Television Service Tips

Volume XXI
Issue 1
January 19, 1970

Prepared and Distributed by **RCA Sales Corporation, Product Performance**
600 N. Sherman Drive, Indianapolis, Indiana 46201

Pulse regulator circuit—CTC 22AD

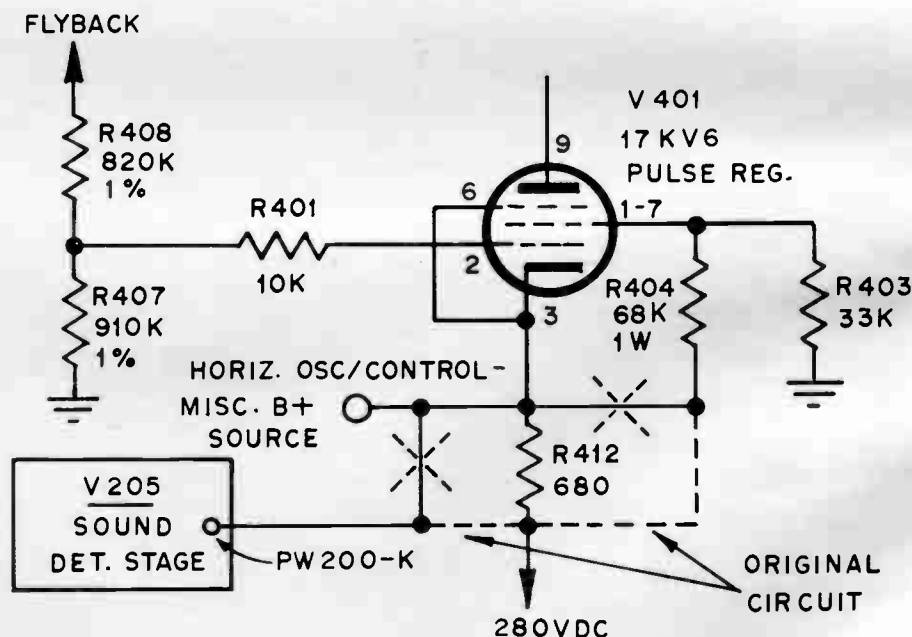
In early-production versions of the CTC 22AD, if Pulse Regulator tube failure in turn causes R412 to open, the instrument may operate, with marginal picture quality after the tube is replaced. The symptoms would be those associated with reduced horizontal drive.

Later-production instruments reflect the circuit changes outlined in the simplified schematic. Changing the B+ source point for the regulator screen grid resistor (R404) as shown "shuts down" horizontal operation in the event of R412 failure. The B+ source for the Sound Detector stage is also changed to this point. Symptoms for R412 failure in instruments with these changes will be: **no sound, no raster**.

In addition, R407 and R408 values may be either 820K, 1% or 910K, 1%. If replacement is required, use the same value resistor as the original. Stock numbers are: 820K, 1%—126429; 910K, 1%—126428. Check high voltage operation (per Service Data) after resistor replacement.

Horizontal deflection circuit—CTC 40

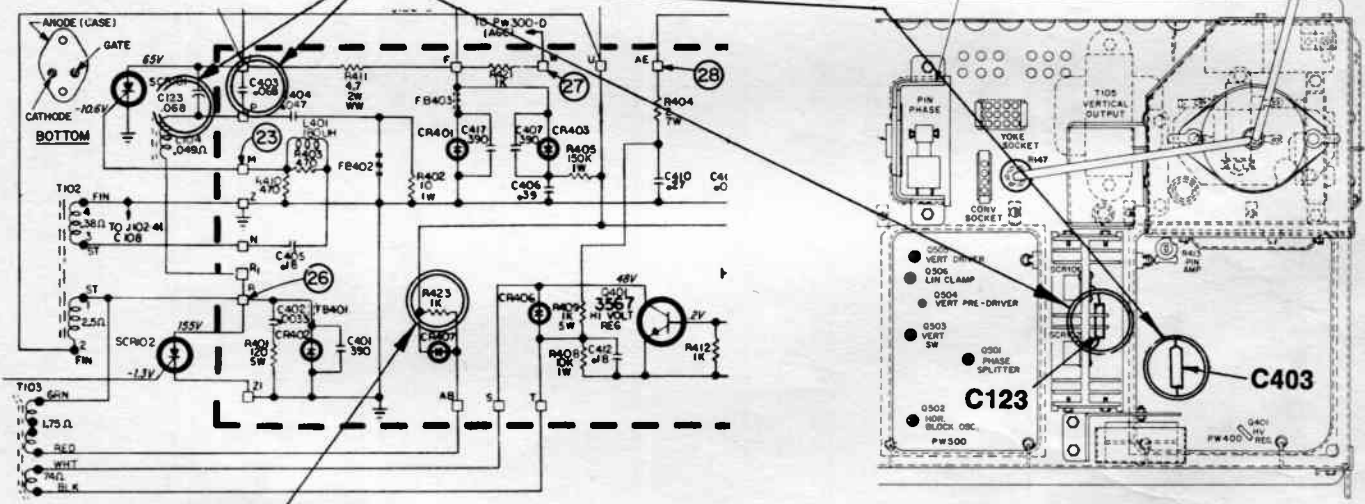
The .068 μ f commutator capacitor used in the horizontal deflection circuit of these chassis is located either on the PW400 board or on a terminal board under the SCR heat sink. Two capacitors in parallel are **never** used. If the capacitor is on PW400, it is C403; off the board, it is C123. In either case, the capacitor is the same type and the replacement stock number is 165437.

“Piecrust” or “geartooth” effect in the raster (scalloped edges) at different brightness levels may be the result of R423 opening. High voltage and brightness limiter operation appear to be normal. In some instances the symptom may be accompanied by a high pitched squeal.

Capacitor may be located either place—never both.

Can cause “piecrust” effect.

Color burst circuit—CTC 38, CTC 39

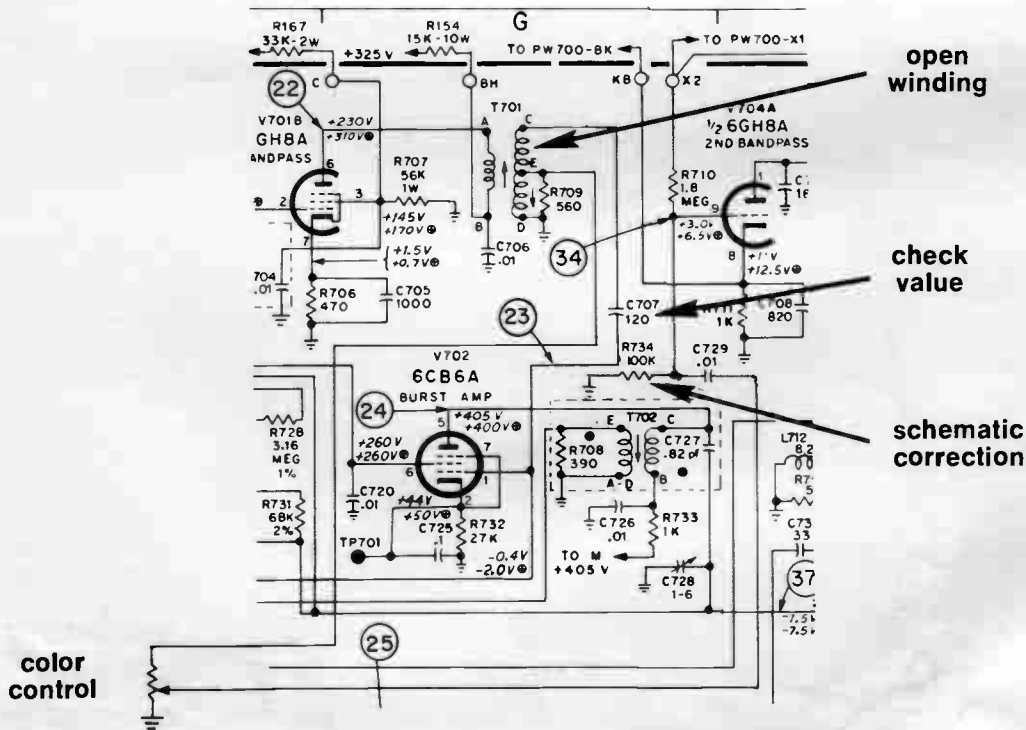
Some symptoms associated with the color sync and/or ACC-killer circuitry in instruments utilizing these chassis may be the result of an open winding in the first bandpass transformer, T701 (Stock No. 124761). If the open occurs in the winding connected between terminals C and E the color signal input to the burst amplifier stage will be incorrect. However, the path for chroma input to the second bandpass amplifier stage will be normal.

In addition, make certain capacitor C707 is the correct value (120pf).

The schematic correction pertains to Service Data 1970 No. T3 only.

First video amplifier circuit—CTC 40

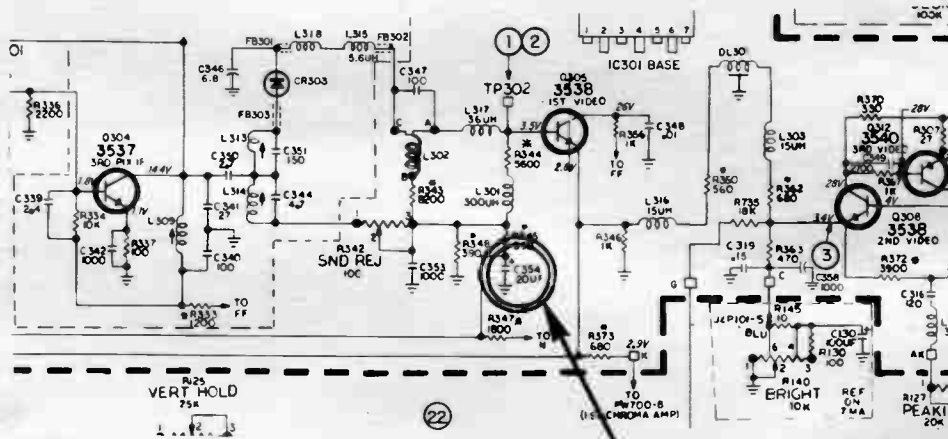
A wide variety of video and/or sync symptoms in these chassis may be the result of an electrolytic capacitor changing value. Possible symptoms include: video "smear"; video "bends"; unstable sync; various combinations of these symptoms. In addition, the symptom may vary with the brightness control setting.

SYMBOL No.	STOCK No.	DRAWING No.	DESCRIPTION
C354	121995	1471882-14	20 μ f, 15V, electrolytic

Check Electrolytic

Filament power circuit—KCS 177

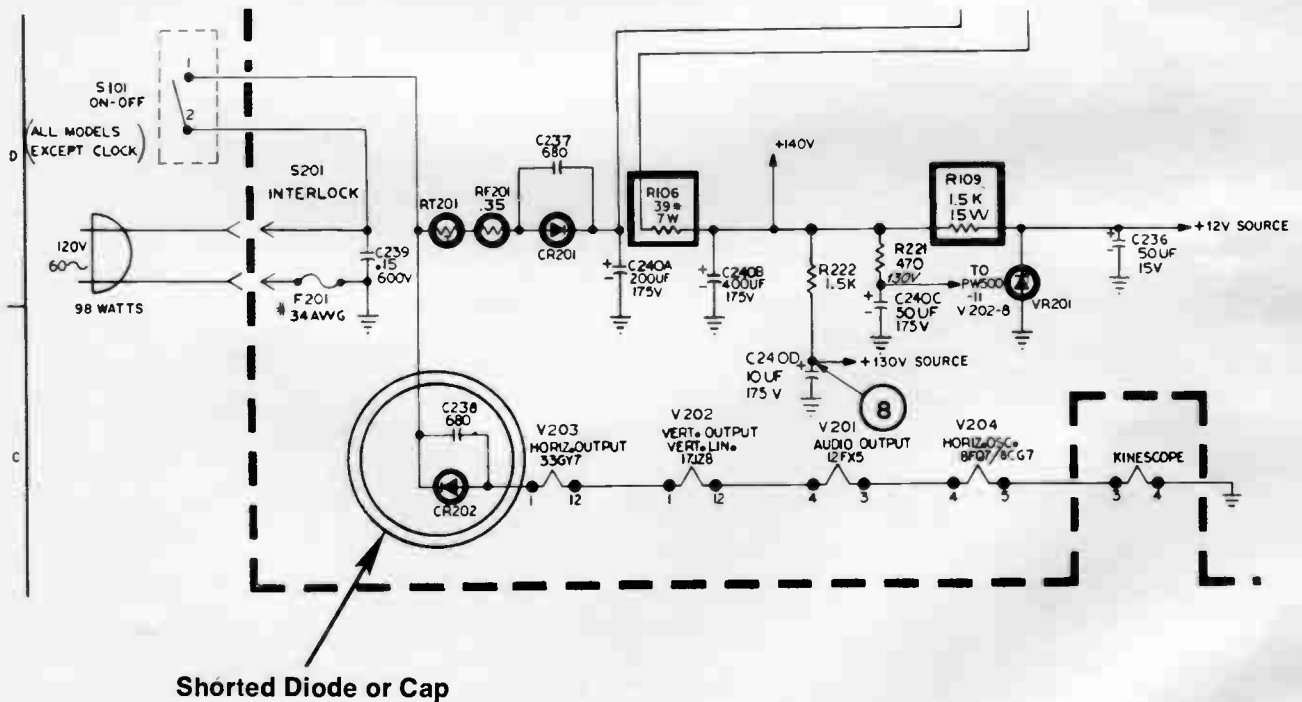
These chassis use a half-wave rectifier for filament power. Should the diode (or the capacitor across it) short, the filament string will be operating on full line voltage (120V AC) rather than the normal half-wave rectifier output. The tube filaments will glow brighter than normal and may result in reduced tube life. In addition, a hum bar in the raster and/or poor vertical sync may be evident.

Remote preamplifier circuit—PW 900

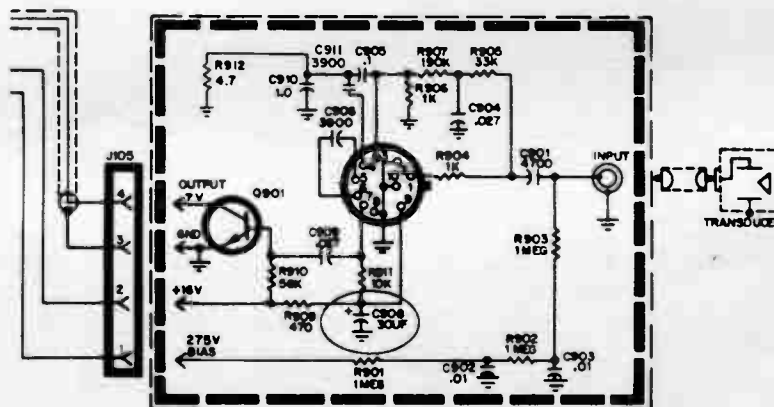
Reduced remote control sensitivity of instruments utilizing these chassis may be the result of an off-value electrolytic capacitor in the preamplifier. The capacitor is:

SYMBOL No.	STOCK No.	DRAWING No.	DESCRIPTION
C908	128058	1471882-19	30 μ f, 15V, electrolytic

If this capacitor must be replaced, for maximum reliability use the following tantalum type:

SYMBOL No.	STOCK No.	DRAWING No.	DESCRIPTION
C908	132062	1446192-14	27 μ f, 15V, electrolytic

Power standby circuit—CTC 40

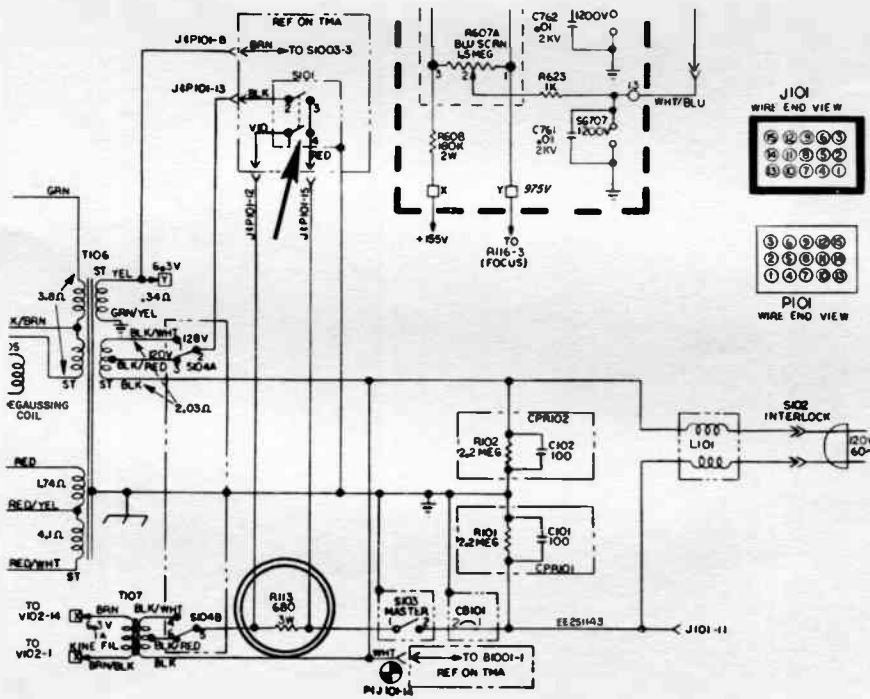
Some color tracking problems in instruments utilizing the CTC 40 chassis—which seem to relate to a defective picture tube—may actually be the result of a defective on/off switch. Should that section of the switch used to bypass the picture tube filament dropping resistor (R113) become intermittent, the filament voltage could vary between 5 (standby) and 6.3 (on) volts. This can cause variations in color tracking.

Remote preamplifier circuit—CTP 13A

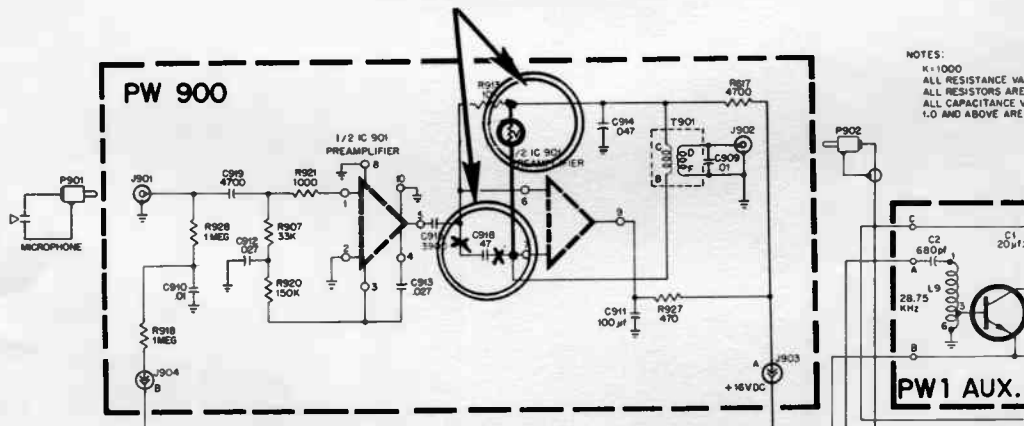
Some versions of the PW900 board utilized in CTP 13A remote amplifiers may have a circuit modification. As shown in the schematic, C918 is deleted and a varistor (Stock No. 130042, Drawing No. 1472668-7) added in parallel with the primary of T901.

Physically, the varistor replaces the capacitor. The printed circuit is modified slightly in order to make the proper connections.

**Capacitor
replaced
with
varistor**

Marginal remote sensitivity in amplifiers that have been modified may be improved by removing the varistor. It is not necessary to replace the capacitor unless high frequency interference is evident in the picture during remote functions.
